STAFF REPORT
COMMUNITY DEVELOPMENT DEPARTMENT

HEARING DATE: December 1, 2022
 TO: Planning & Zoning Commission
 FROM: Sonya Allen, Associate Planner
 208-884-5533
 SUBJECT: H-2022-0027
 Sagarra – PUD, PP
 (aka Linder Village)
 LOCATION: South side of W. Orchard Park Dr., west of N. Fox Run Way, east of N. Linder Rd., in the NW 1/4 and NE 1/4 of Section 25, T.4N., R.1W. (Parcels #R5262501800, R5262502100 & #R6905540100)

DRAWING TITLE
LANDSCAPE PLAN - OVERALL

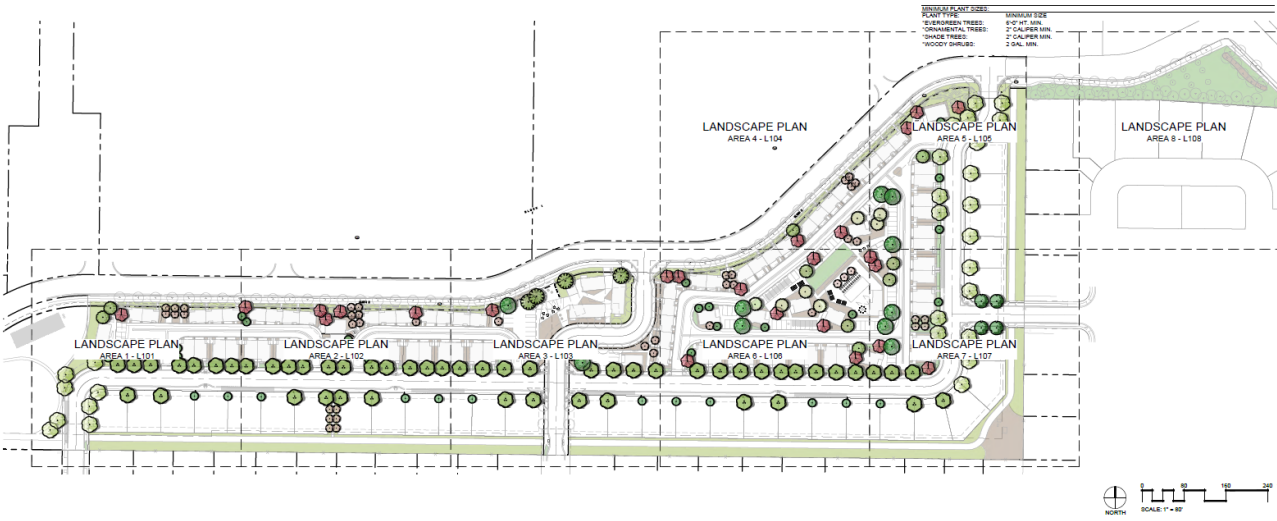
road/multi-use pathway is proposed is encompassed by an irrigation easement that prohibits trees within the easement. **Prior to the City Council hearing, an Alternative Compliance application should be submitted to relocate the trees required in this area to along micro-paths within the development, as proposed; shrubs and other plantings should be provided within this area if allowed by the easement holder in accord with UDC 11-3B-12C.2.**

- Submit an application for Alternative Compliance to UDC 11-3B-12C, which requires a minimum of one (1) tree per 100 linear feet of pathway, to relocate the trees required in the common lot along the south and east boundaries of the site to along micro-paths within the development as proposed on the landscape plan.

- c. Depict landscaping along all the foundation of all street facing elevations in accord with the standards listed in UDC [11-4-3-27E](#).
 - d. Depict shrubs and other plantings adjacent to the pathway along the south and east boundaries of the site in accord with UDC [11-3B-12C](#) as allowed by the Irrigation District within their easement.

G. Vehicular & Pedestrian Circulation Plan

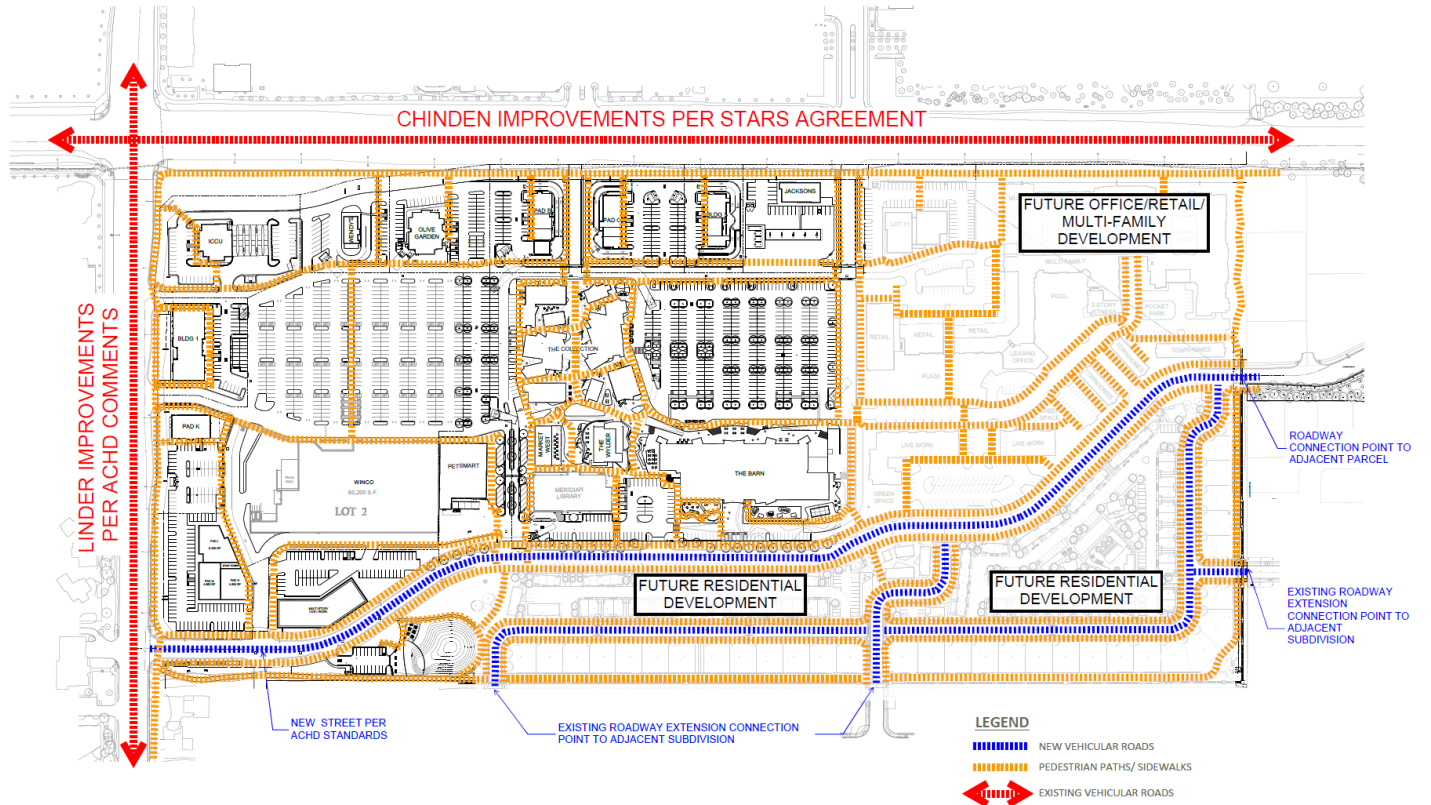
15. Future development shall comply with the vehicular and pedestrian circulation plan in Section VII.G.
 16. A Design Review application shall be submitted for *all* structures within the development to ensure quality of design for an exemplary development. All structures shall comply with the design standards in the [Architectural Standards Manual](#) unless otherwise approved through a design standard exception.
